**SAFETY EVALUATION REPORT
REQUEST FOR RELEASE OF THE SINCLAIR FARM ANIMAL BURIAL SITE
FOR UNRESTRICTED USE PURSUANT TO 10 CFR 20.1402**

Figure 2 Map of the Locations of Subsurface Samples of Tract 7. (samples from the grid pattern are shown in red whereas judgmental sample locations are shown in white with the letter 'J')

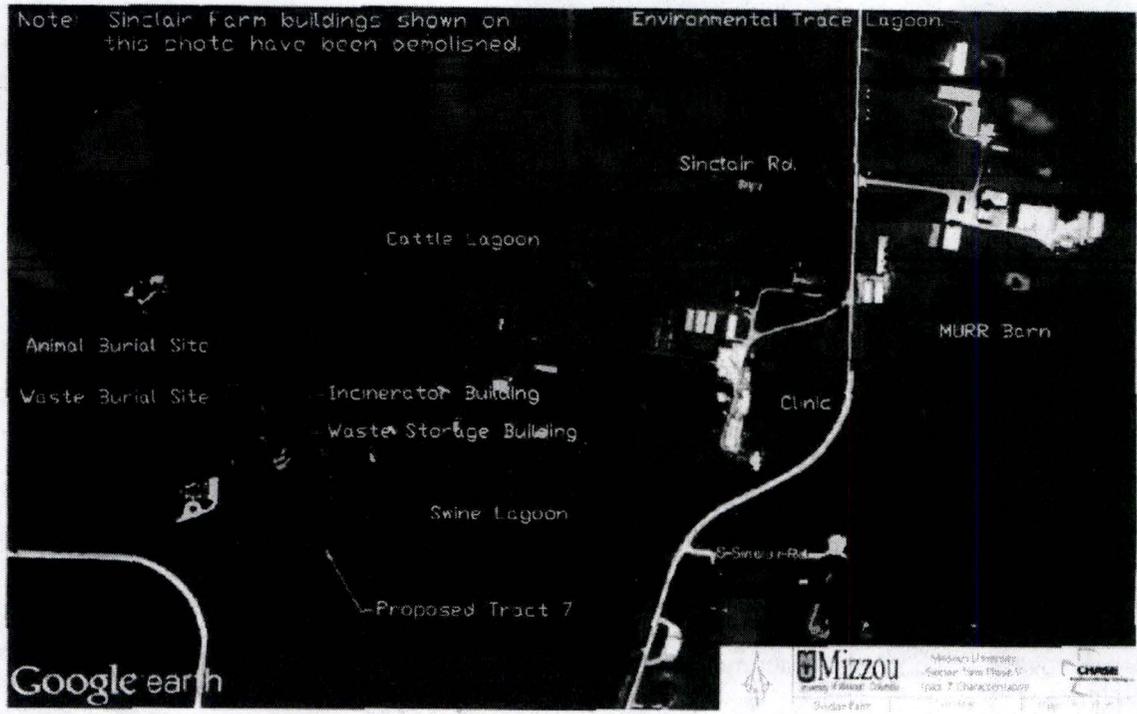
Staff evaluated the overall sampling approach as well as the specific sampling locations and results. Though the Multi-Agency Radiation Site Survey and Investigation Manual (MARSSIM) does not apply to subsurface soils, the licensee considered MARSSIM protocols in its sampling approach. As shown in Figure 2, the licensee used a sampling grid supplemented with judgmental locations. Most sample results were below the minimum detectable concentrations. For the ABS, there is no significant statistical or visual pattern in the observed concentrations of C-14 and H-3 with depth of sample. A higher fraction of the results that were above the minimum detectable concentrations were in the center of the sampled area than at the boundaries.
